**THIRD ADDENDUM TO INVITATION TO BID
FOR THE DURHAM WRRF ODOR CONTROL PHASE 3 HEADWORKS
PROJECT NO. 7202**

CLEAN WATER SERVICES

ISSUED: APRIL 20, 2026

B SECTION
1/4" = 1'-0"
200-S-141
200-S-151

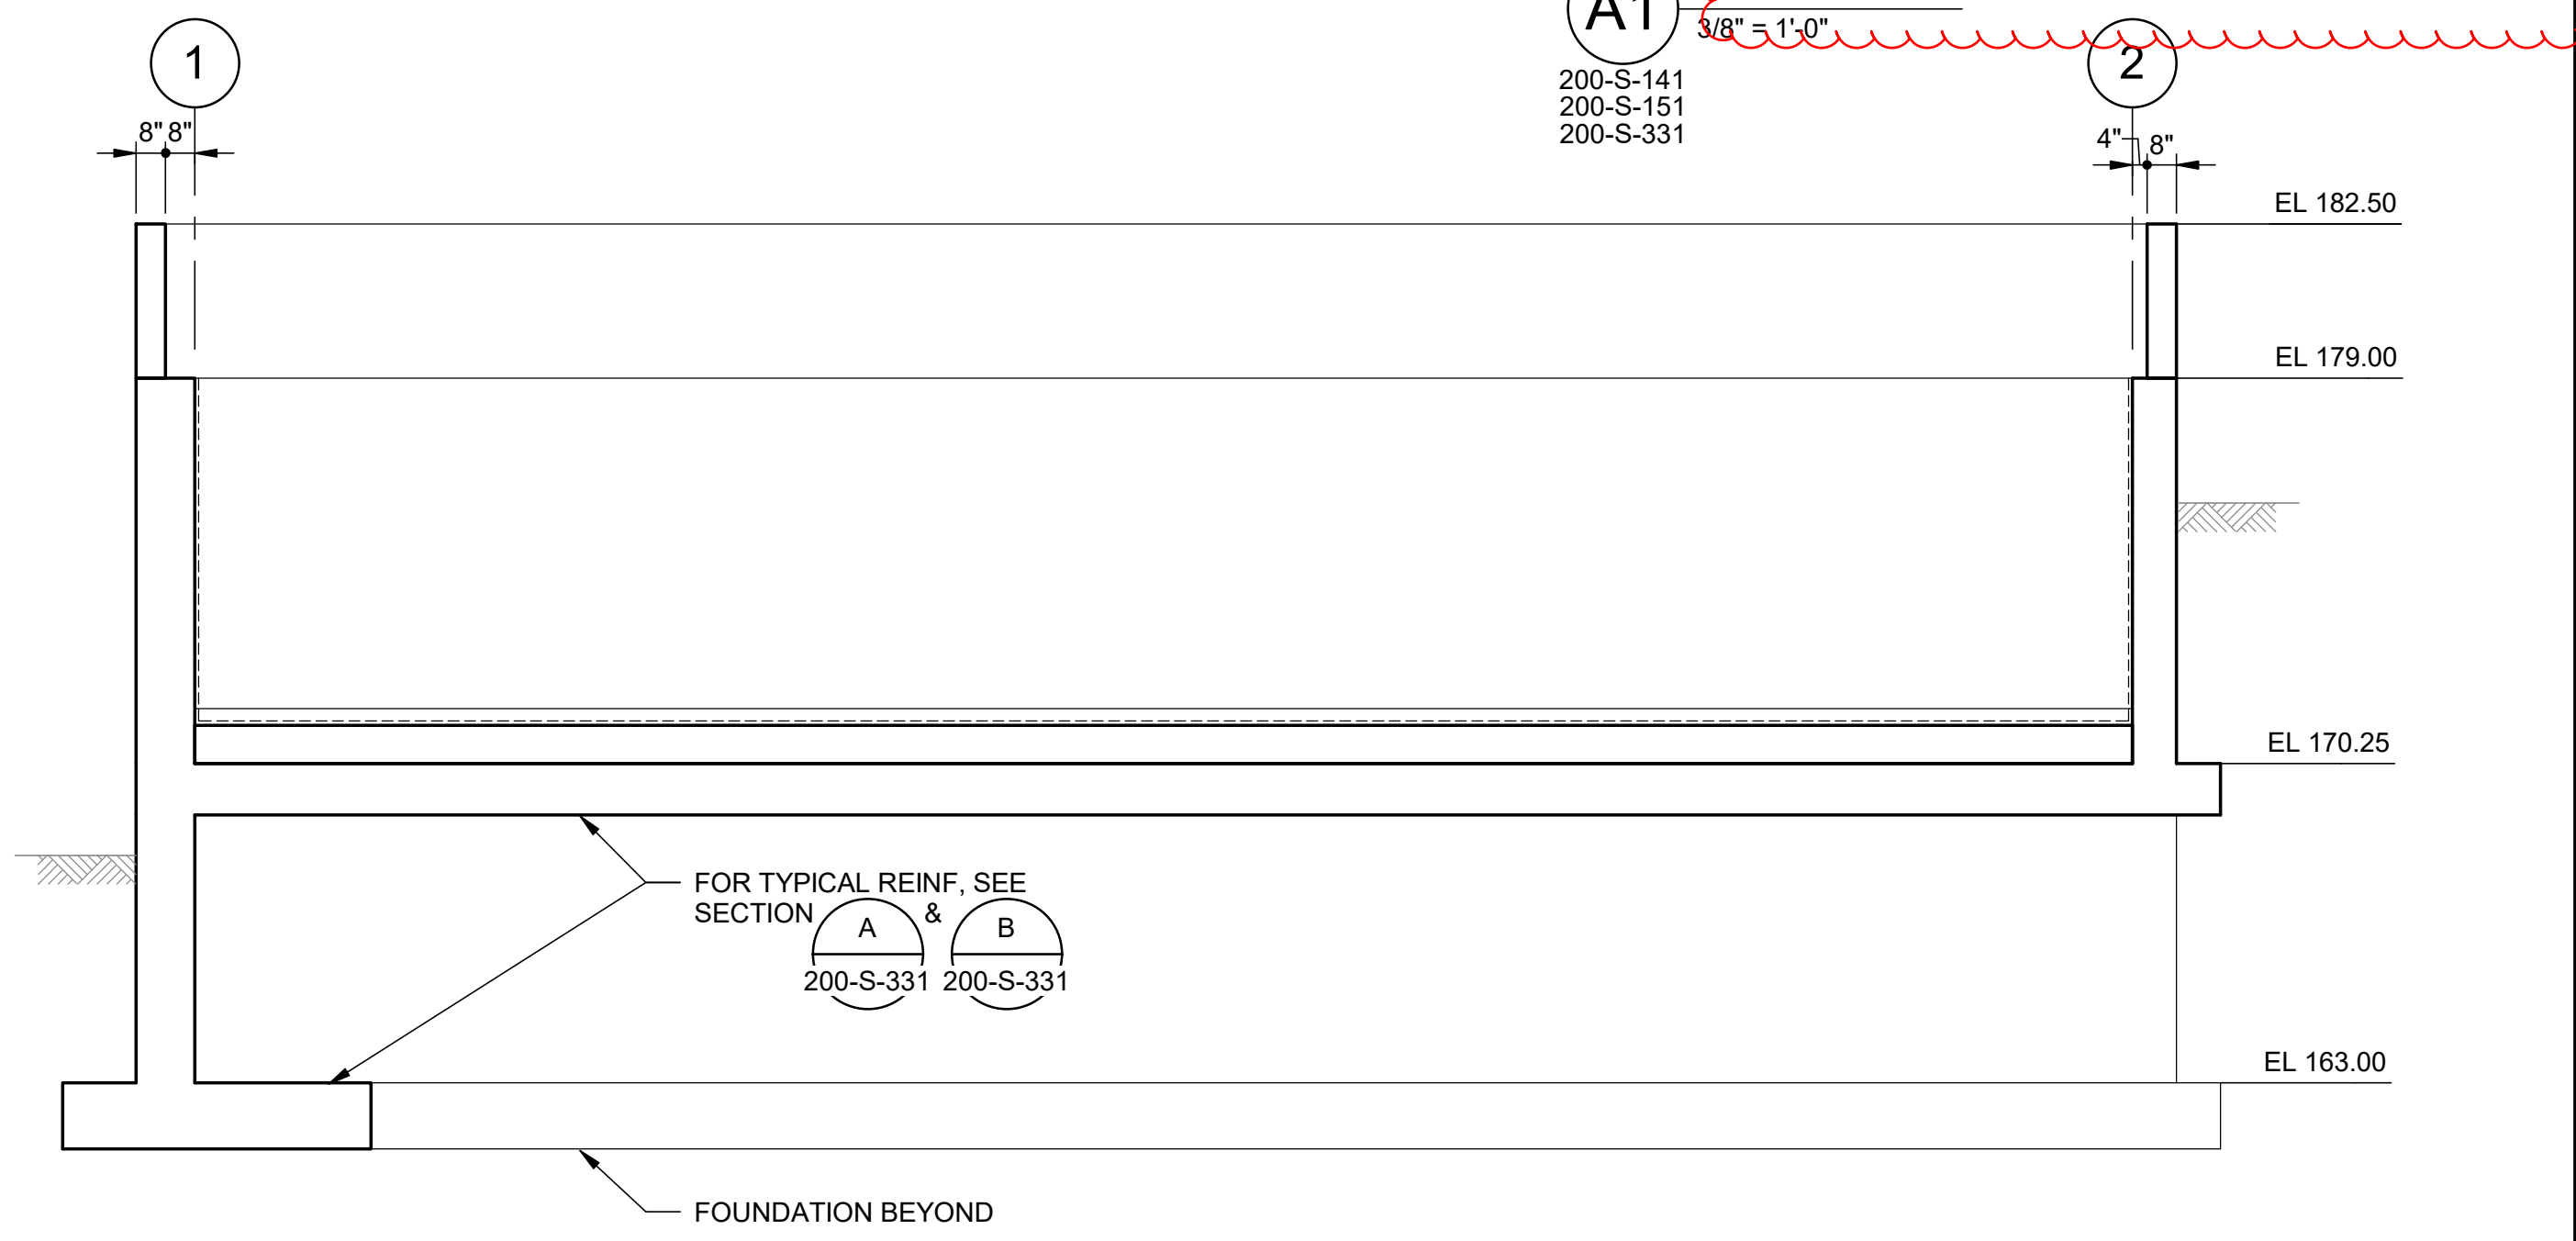
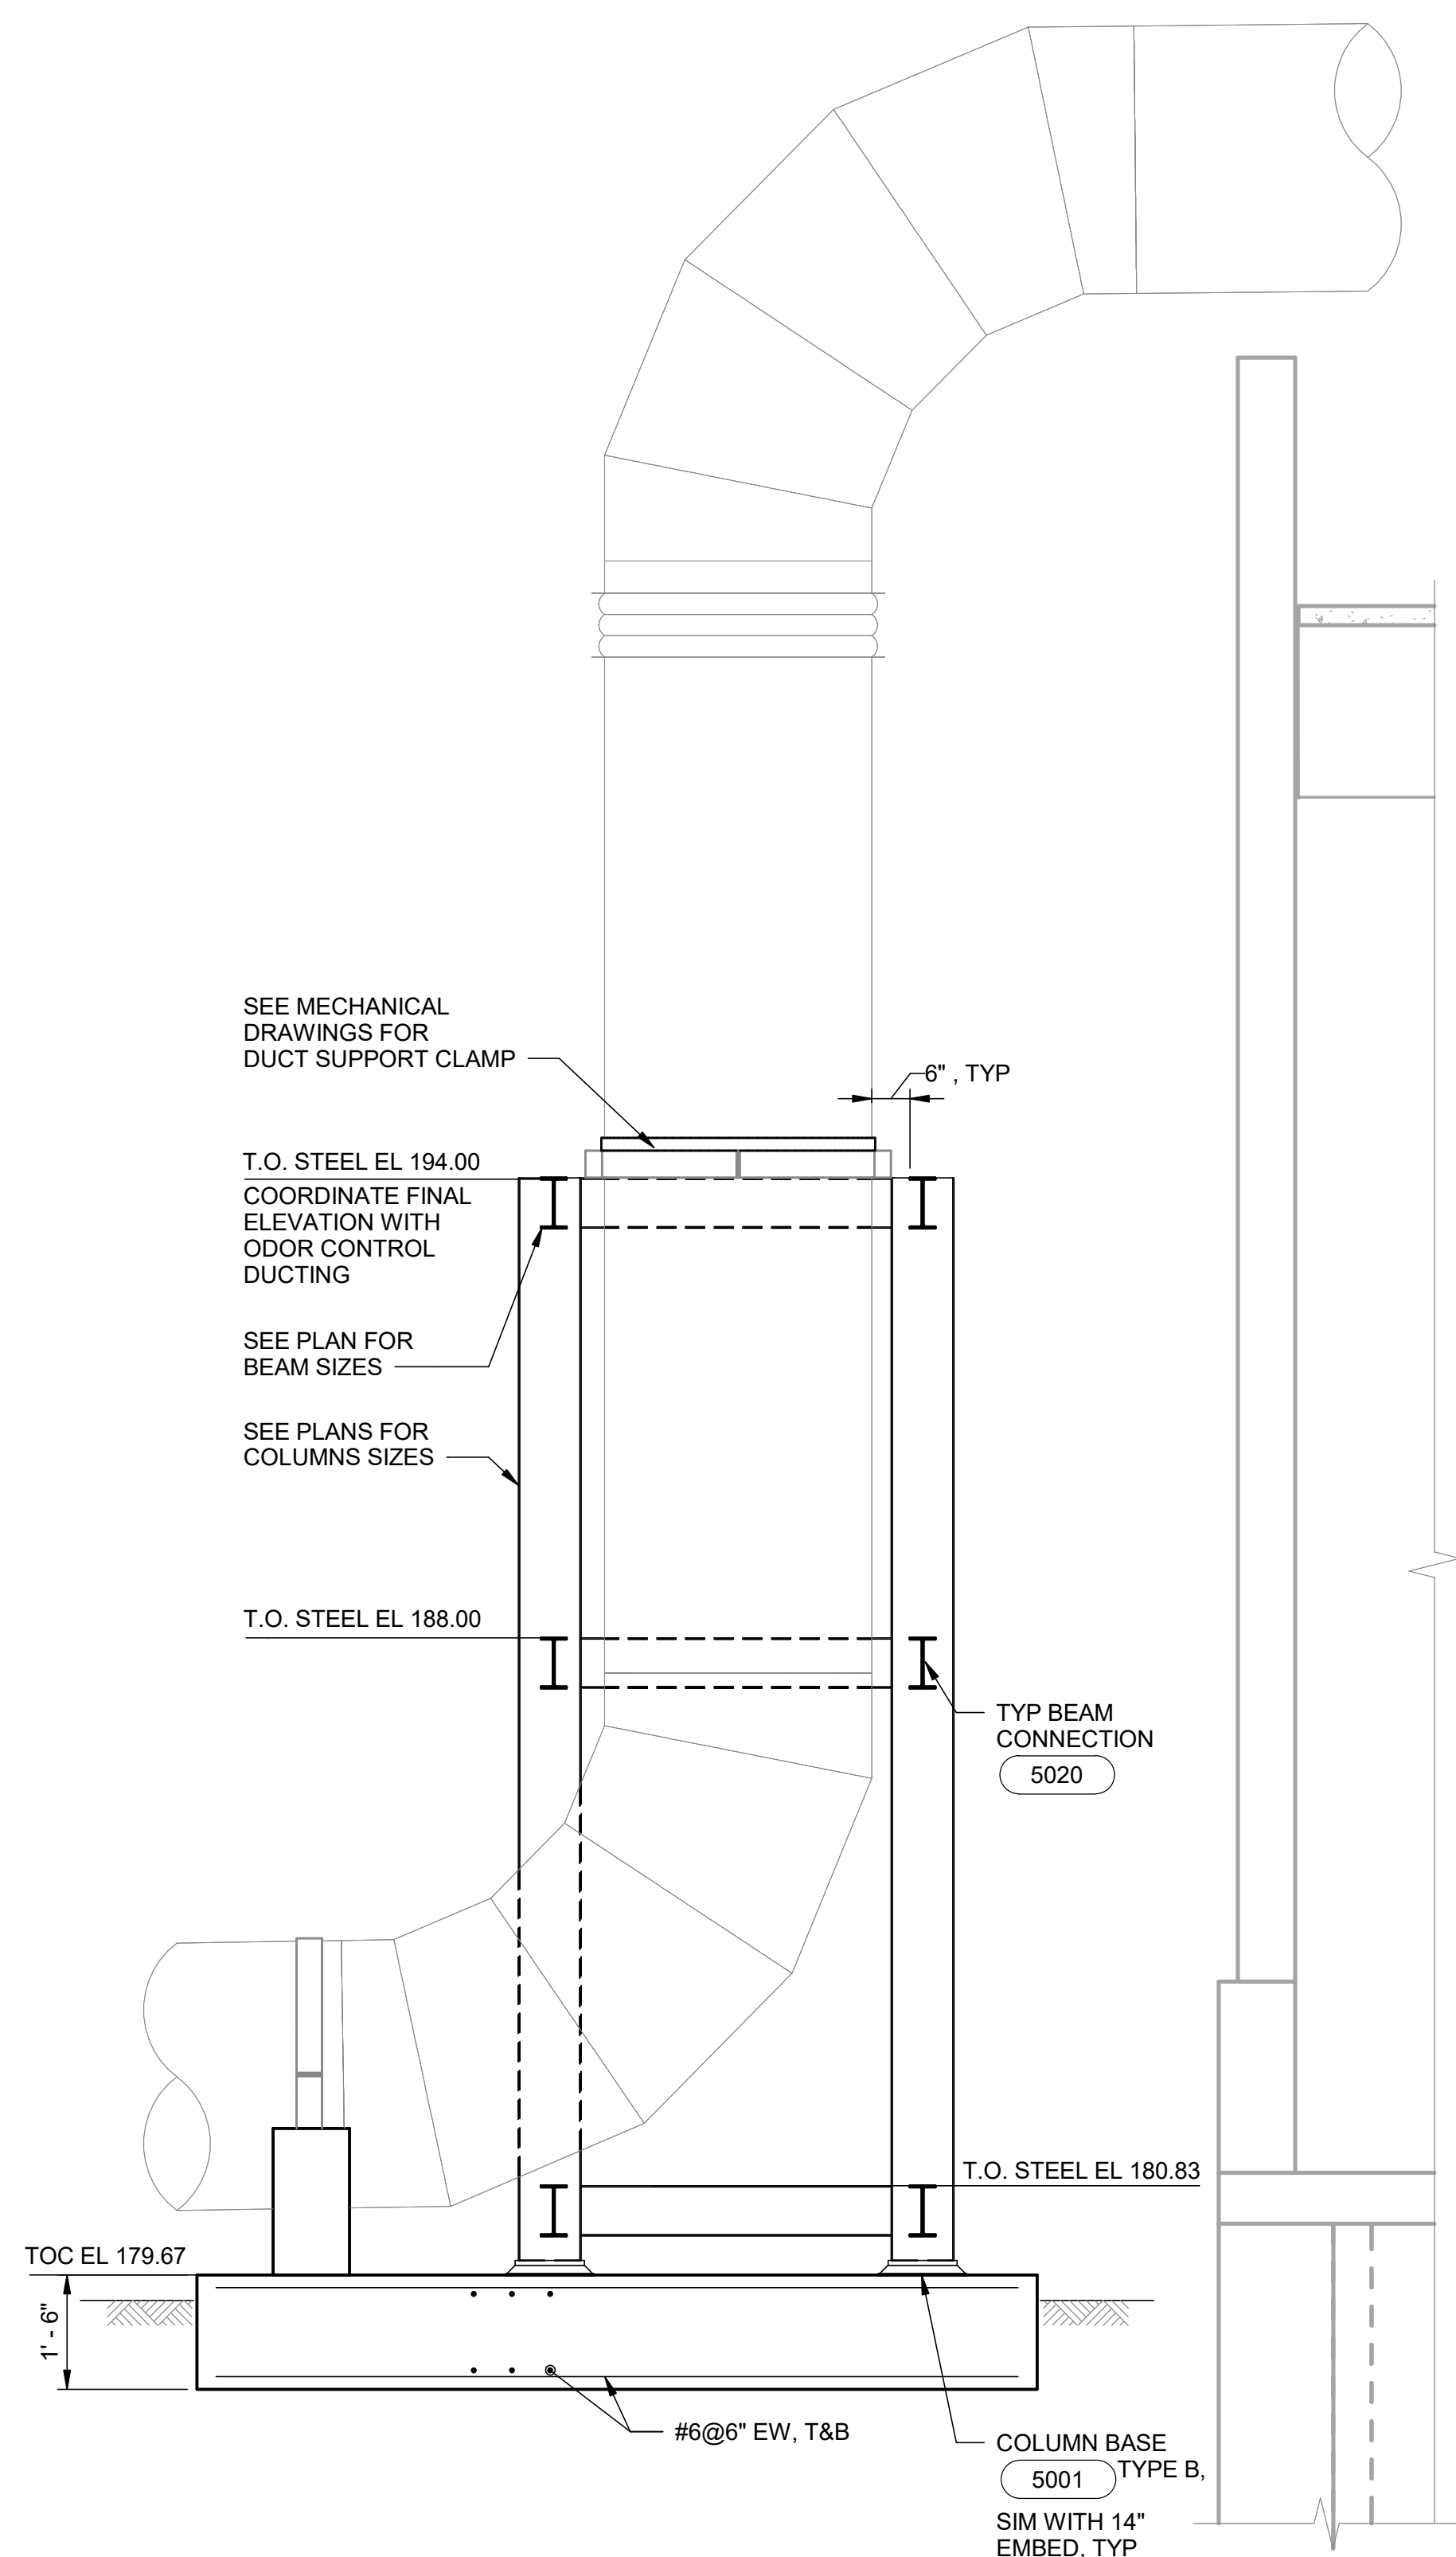
- c. Delete the following Drawings and replace them with the Drawings included in Exhibit A of this Addendum:

1. 200-S-331
2. 200-S-333

EXISTING SLAB OPENING REPAIR

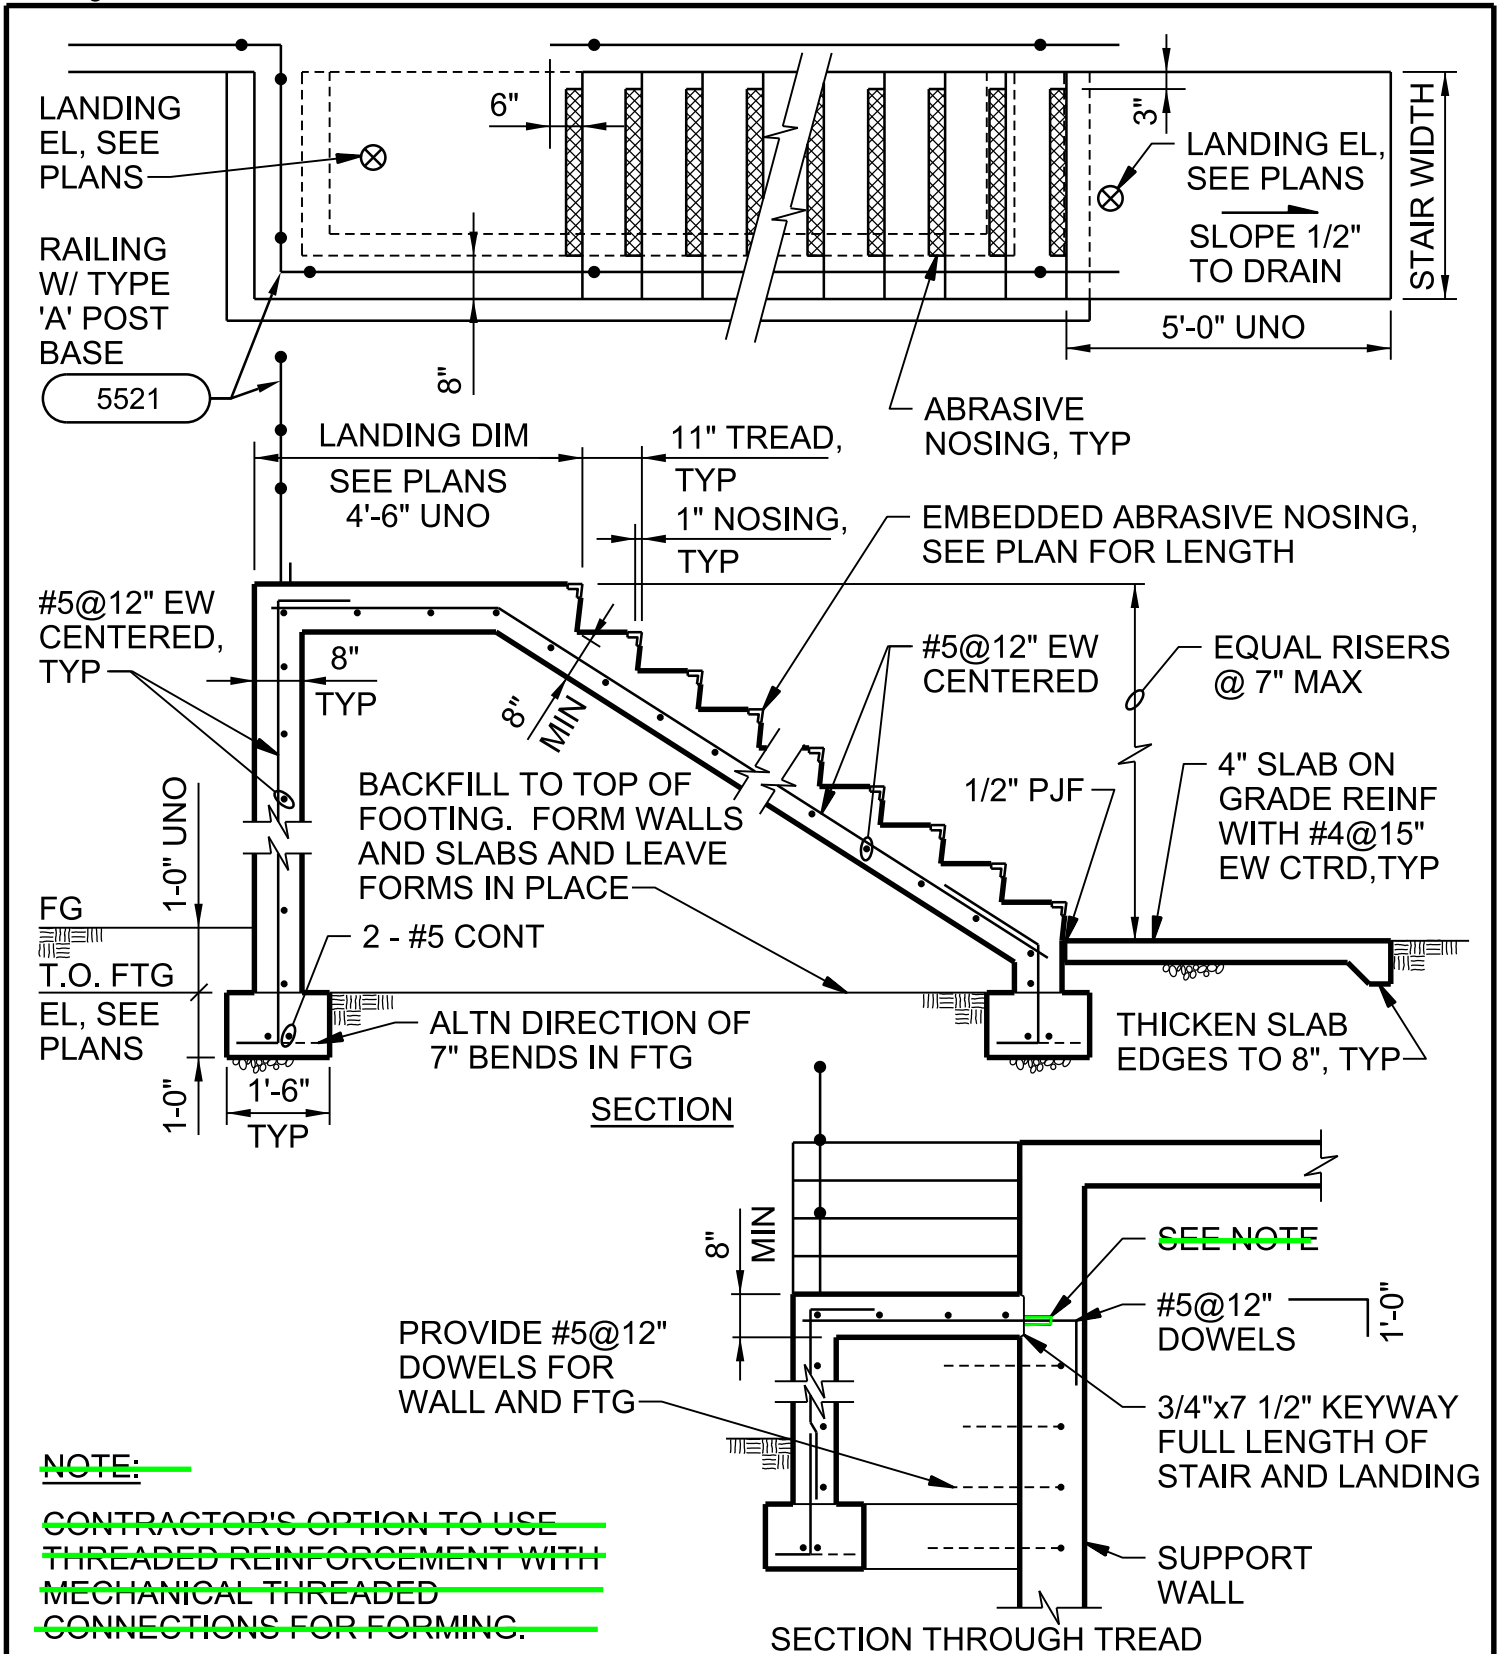
- a. Delete the following Standard Detail in its entirety:
 - 1. 3143 SLAB CONSTRUCTION JOINT AT WALL
- b. Delete the following Standard Details and replace them with the Standard Details included in Exhibit A of this Addendum:
 - 1. 3271 EXISTING SLAB OPENING REPAIR
 - 2. 3348 CONCRETE STAIR – WITH CLOSURE WALL
 - 3. 3361 PIPE SUPPORT – CONCRETE SADDLE (1 OF 4)
 - 4. 5501 STAIR DETAILS – ALUMINUM (2 OF 4)
 - 5. 16325b TRENCH AND CONDUIT PLACEMENT

NOTE:
 PROVIDE SHORING UNTIL CONCRETE HAS REACHED 28-DAY COMPRESSIVE STRENGTH.

CONCRETE STAIR - WITH CLOSURE WALL

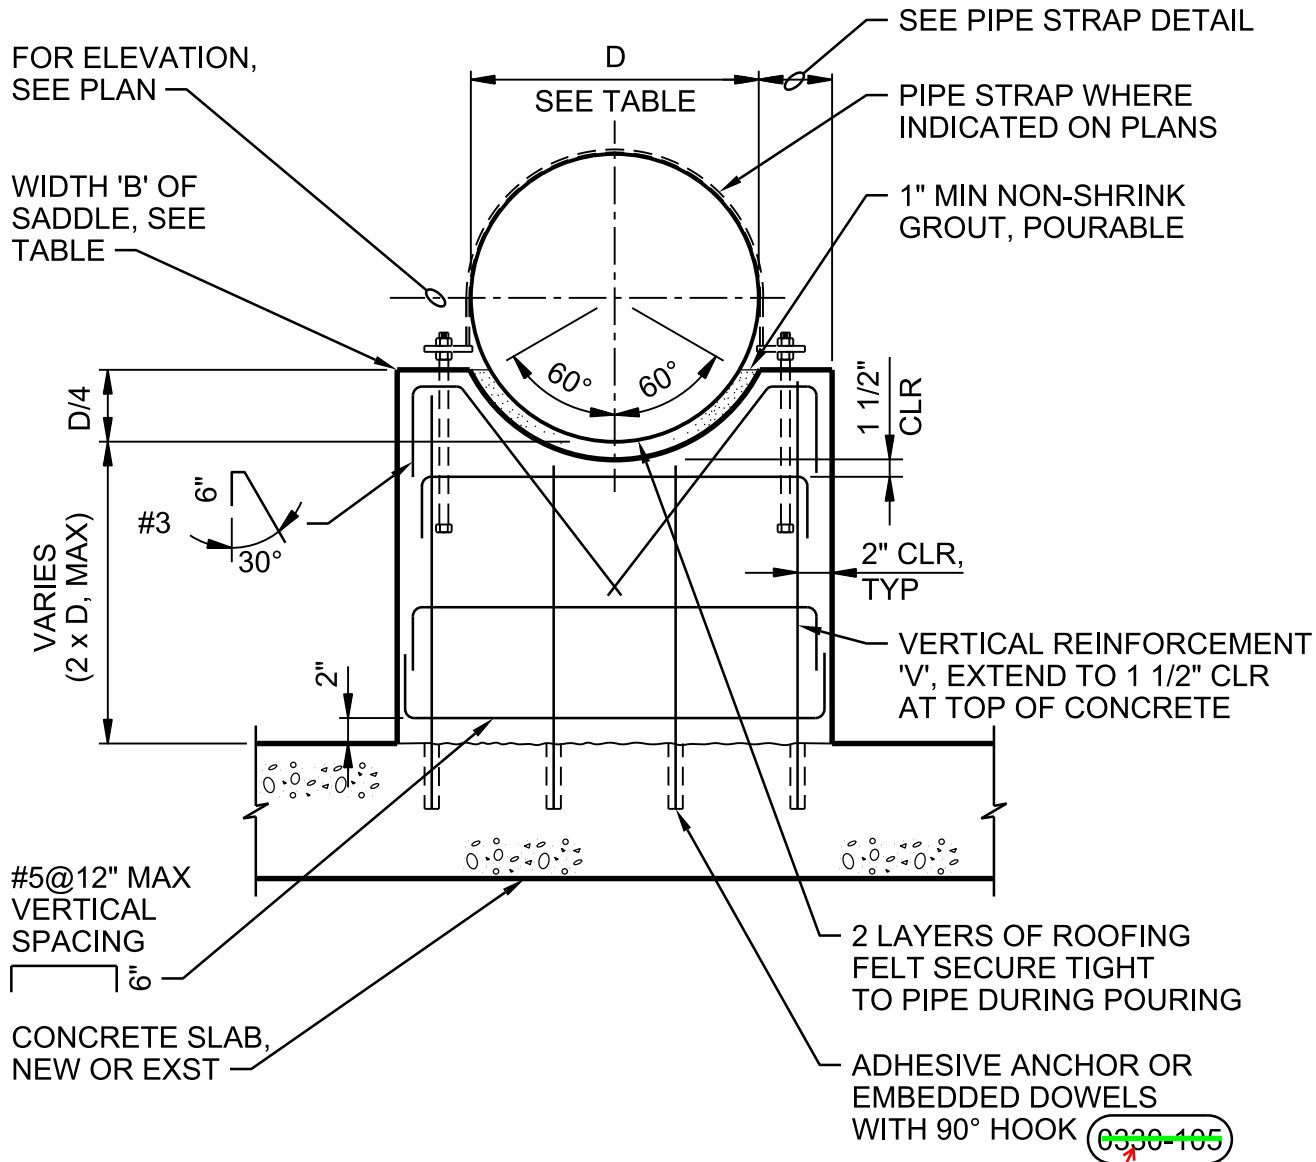
~~CONTRACTOR'S OPTION TO USE
 THREADED REINFORCEMENT WITH
 MECHANICAL THREADED
 CONNECTIONS FOR FORMING.~~
